**Subject: Application for a Permit Modification for Section 404 and 401 permits For the improvements to SR 1400 (Cliffdale Road) from US 401 to SR 1403 (Reilly Road), Cumberland County. TIP No. U-2520; Federal Aid No. STP-1400(2); State Project No. 8.2441701; USACE Action ID 200200640; DWQ Project No. 020400. \$475 to WBS No. 34818.1.1**

The purpose of this submittal is to request a modification to the Section 404 permit and Section 401 Water Quality Certification. The modification for the permit is for additional stream impacts of 95 feet to Site 4.

**Permit Drawing 9 of 11/Site 4**

**SITE 4 - L- STA. 58+77 LT. & RT.**

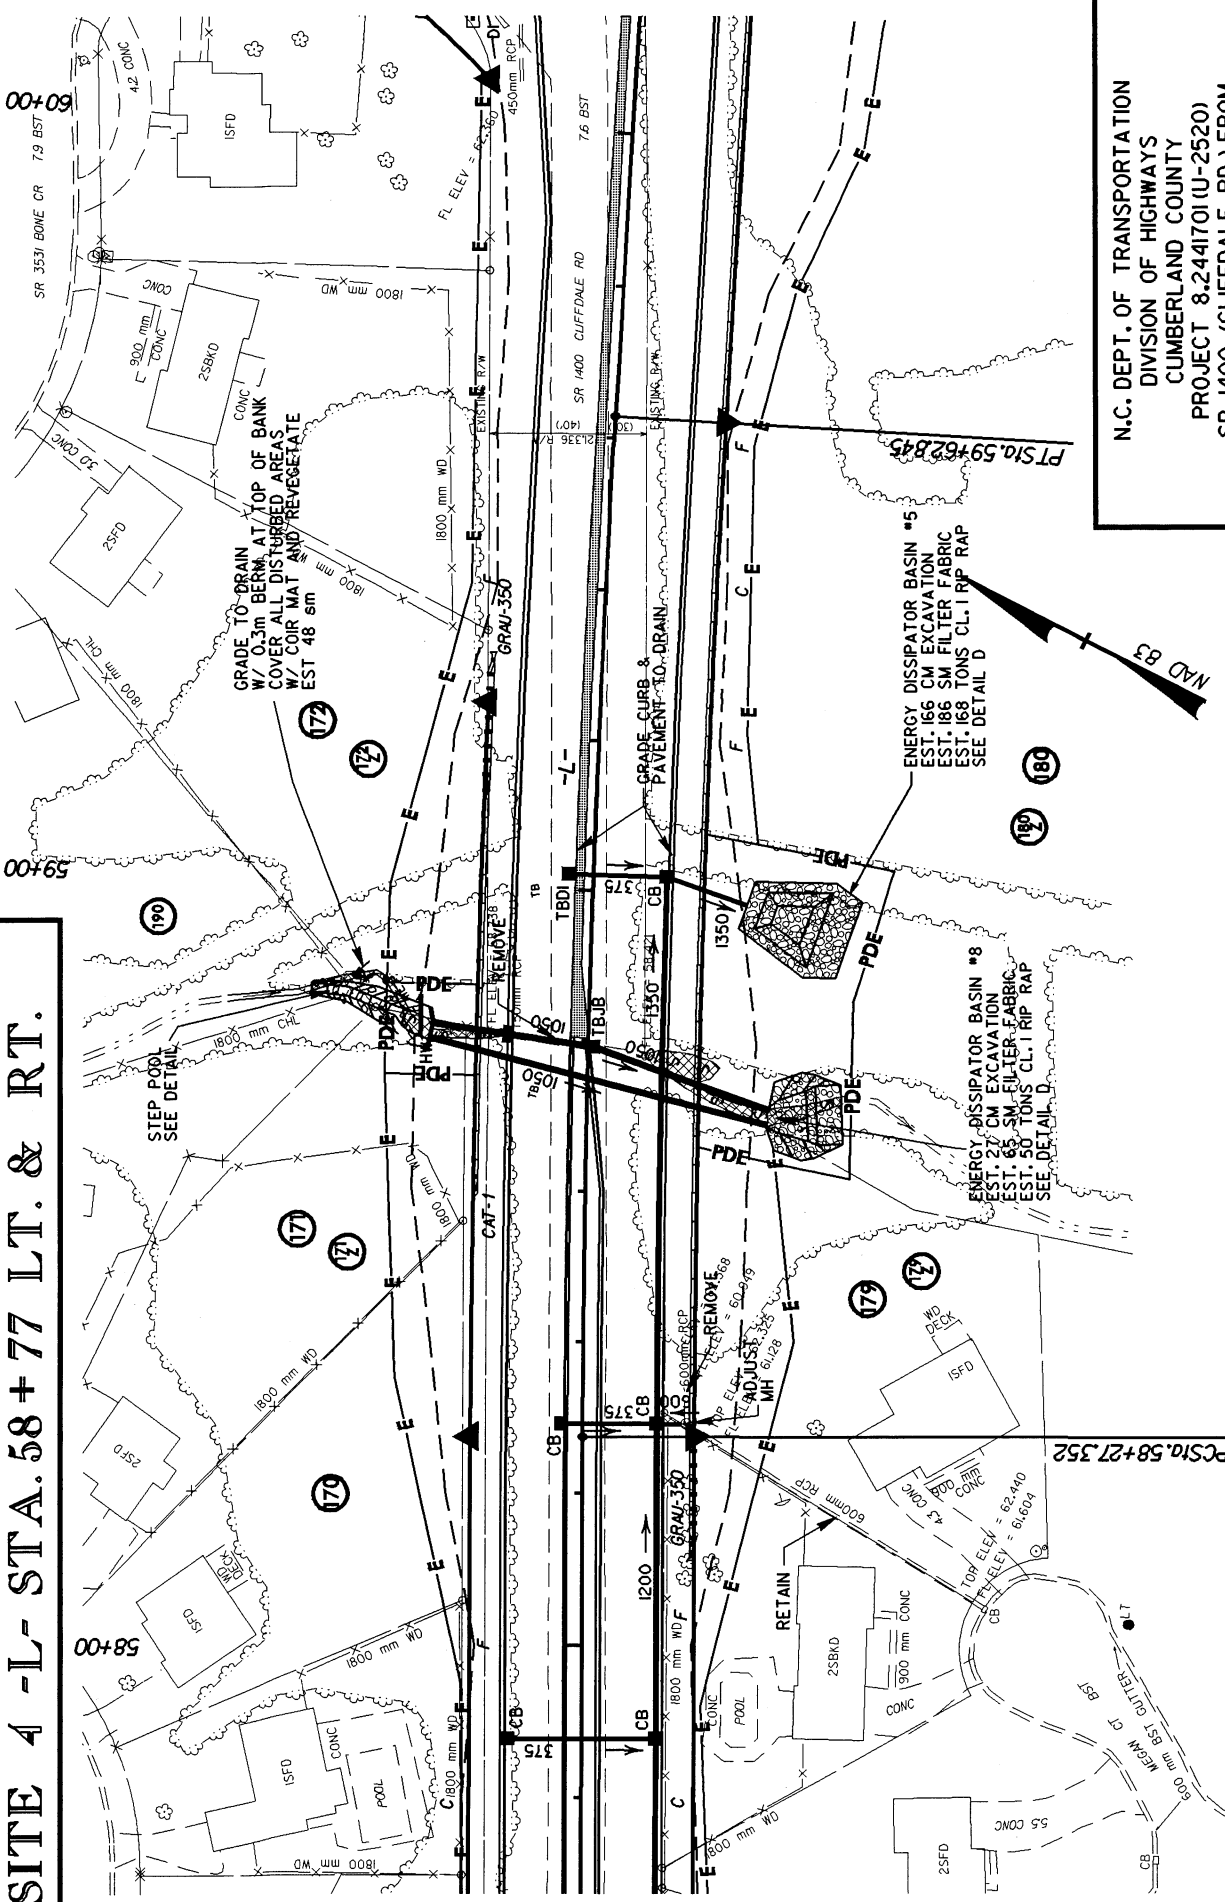
The stream at this site was not shown correctly on the plans and so at the inlet of this culvert, the stream is eroding, scouring and headcutting upstream. To control the erosion and provide stability for this stream a step pool is designed at the inlet. The step pool is 58 ft and the design is enclosed with this application.

At the outlet of this culvert a rip rap pad with an energy dissipator basin is needed to dissipate the water coming out of the culvert.

A preformed scour hole was changed to a energy dissipator basin near this site for the same reason as above. .

The additional impacts to both of these areas at Site 4 are 95 ft. This stream is intermittent and did not require mitigation in the original permit so no mitigation is required for these additional impacts.
